DOCUMENT CHANGE REQUEST

DCR number 272 Changes required for: General

Title: Diodes, Silicon, Power Rectifier , High Efficiency, Fast Recovery, based on type BYW81-200

Number: 5103/029

1.7.1 Metal Flange Mount Package (TO-254) - 3 lead

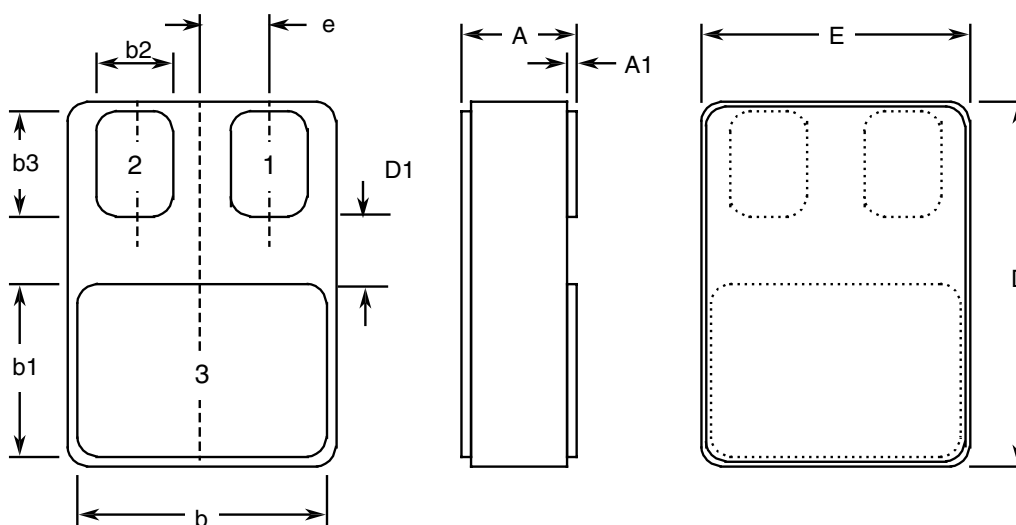
1. Rewording and restructure of various sections and paragraphs of the specification plus other editorial changes based on the layout and editorial content of other Detail Specifications already converted to ESCC format.
2. Deletion of any redundant paragraphs and information, e.g. the mechanical paragraph.
3. Table 1(a) . Lead material and Finish corrected from .P14. to .Q14. for Variant 05.(was typo)
4. Figure 1 Parameter Derating Requirements - moved to be a note to the Maximum Ratings table.
5. New paragraph for Beryllium Oxide handling precautions added for type variants with the TO-245 package.
6. Figure 2(a) - Dimensions .H., .J. and .K. corrected from "Typical" to "BSC". Dimension .I. corrected to .fI. and .M. to .fM..
7. Figure 2(b) . New drawing added to harmonise this SMD.5 package outline with all other ESCC specifications with this
